HVAC Renovations for Waltham Public Library, 2024

ADDENDUM NO. 5

MARCH 7, 2024

M-2.4

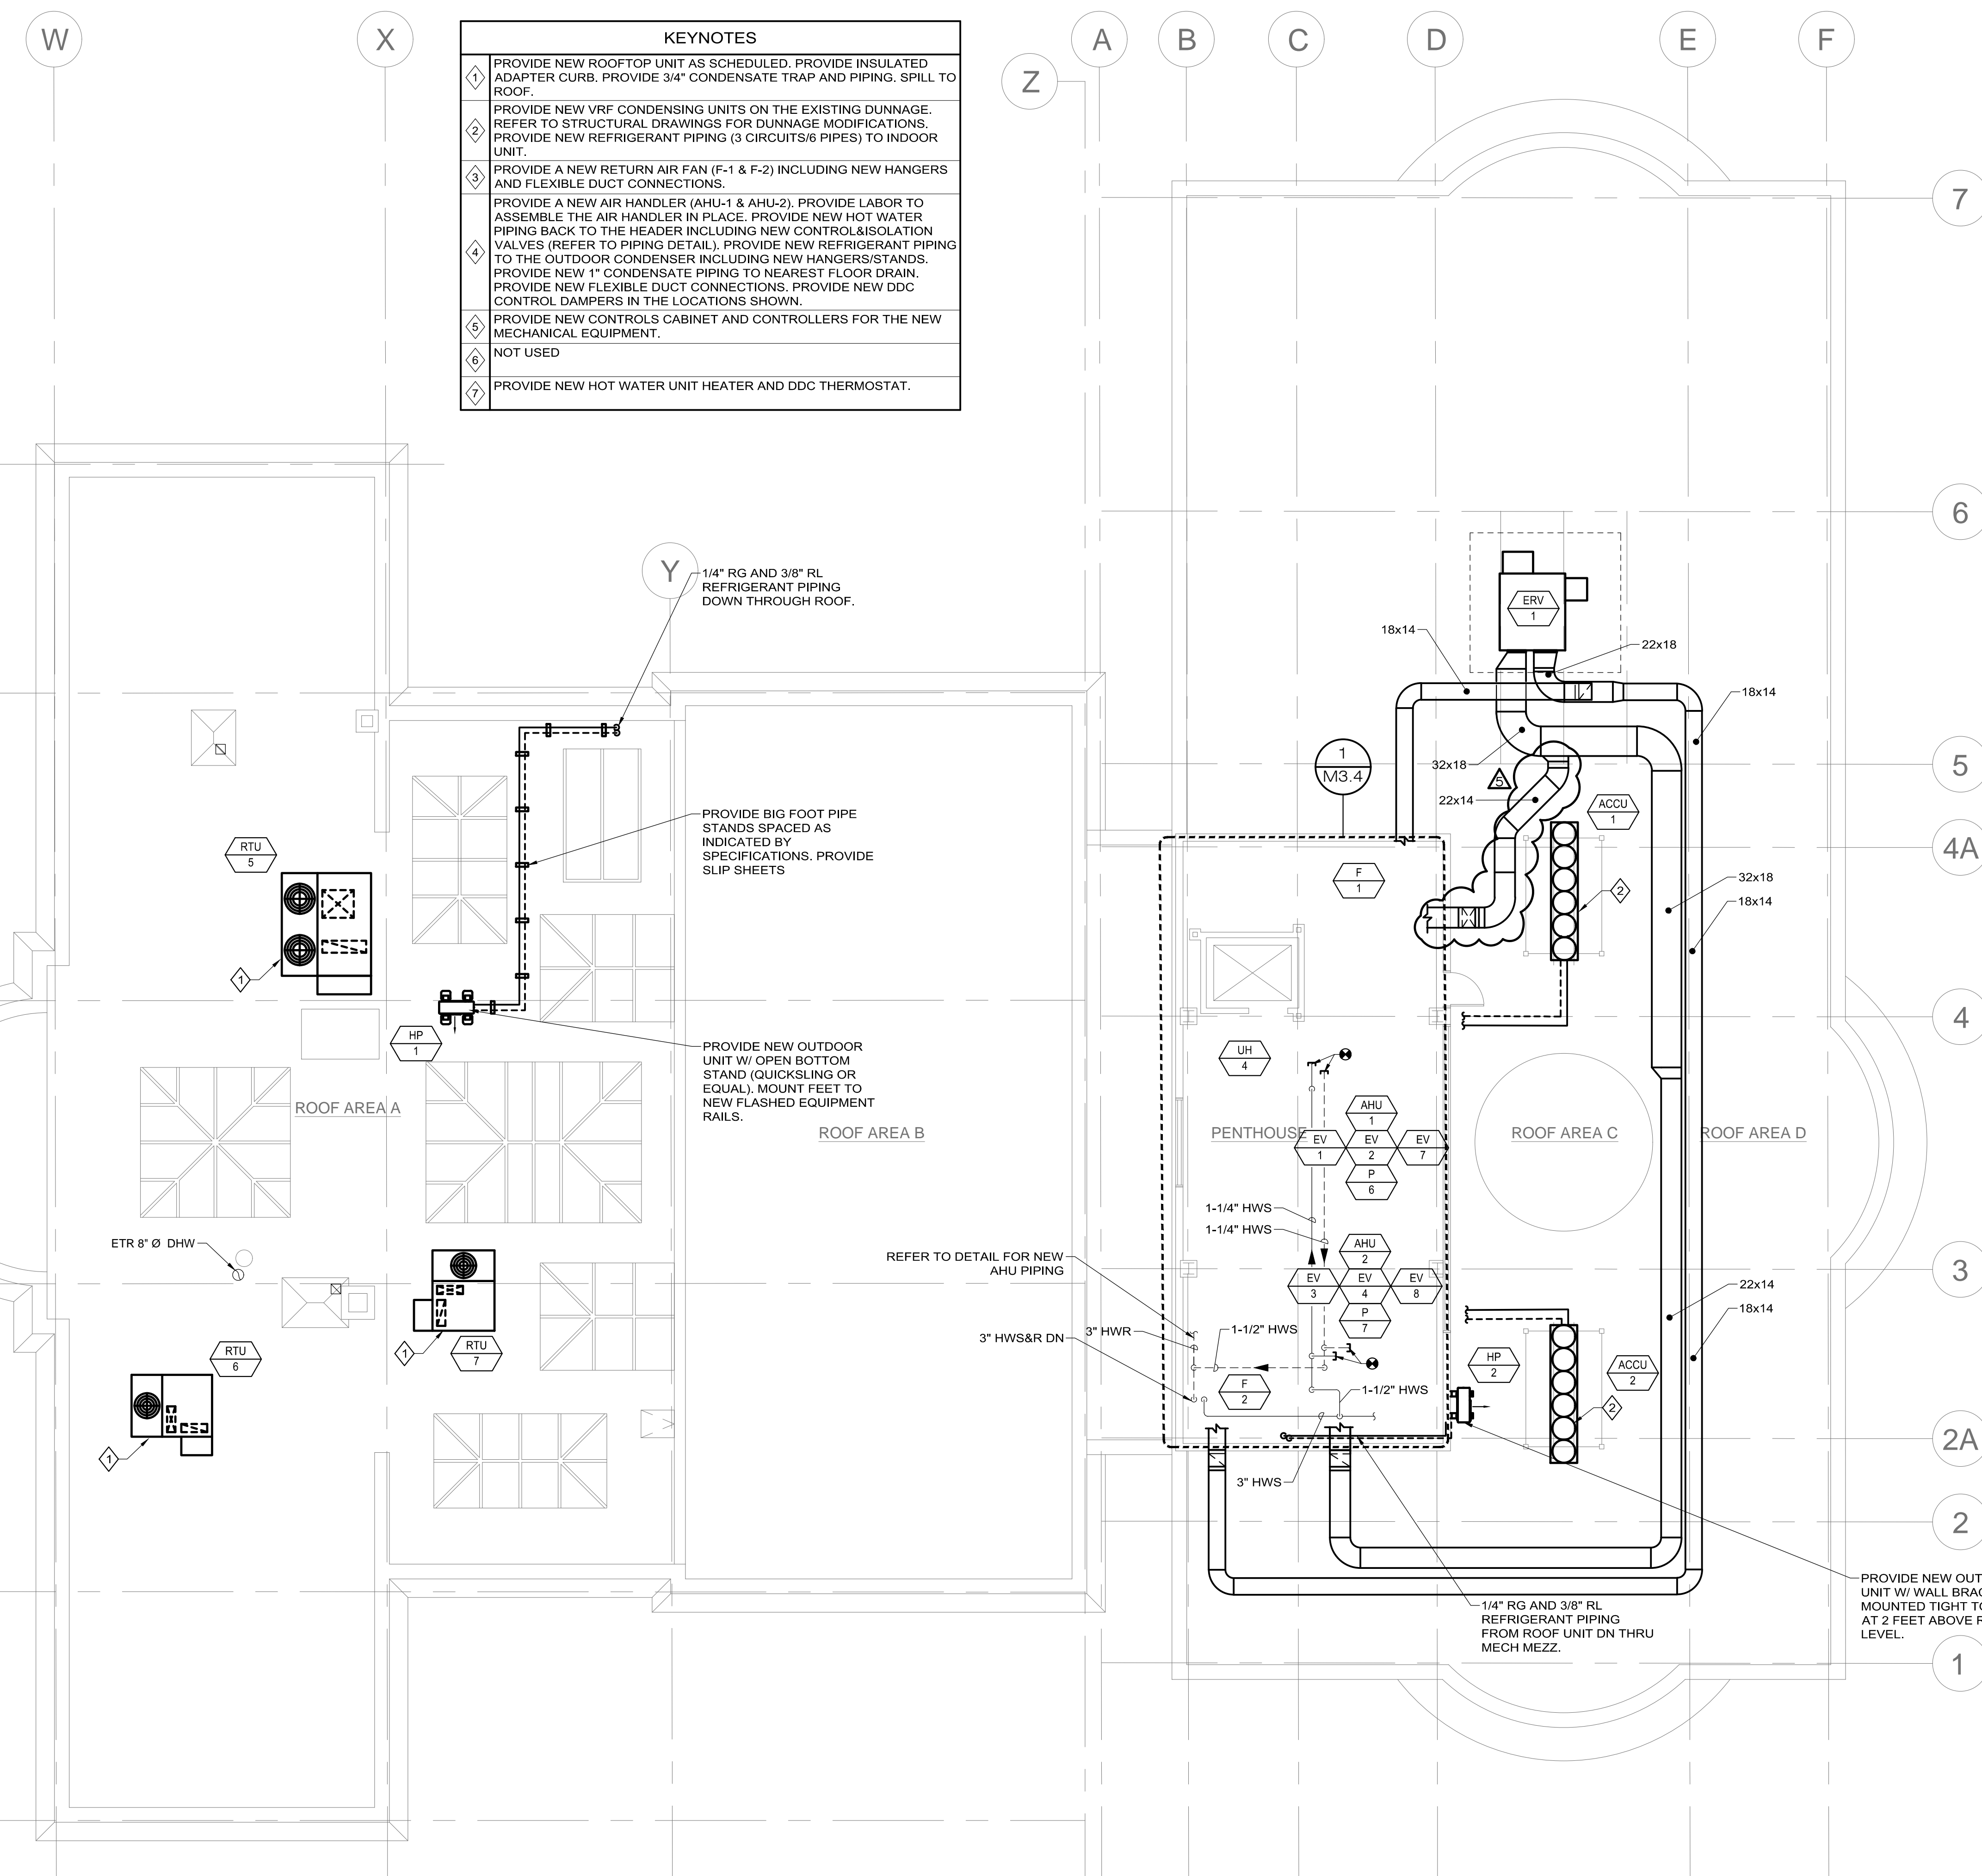
1. See revised duct location on the attached Mechanical Drawings:
 - M-2.4
 - M-3.4
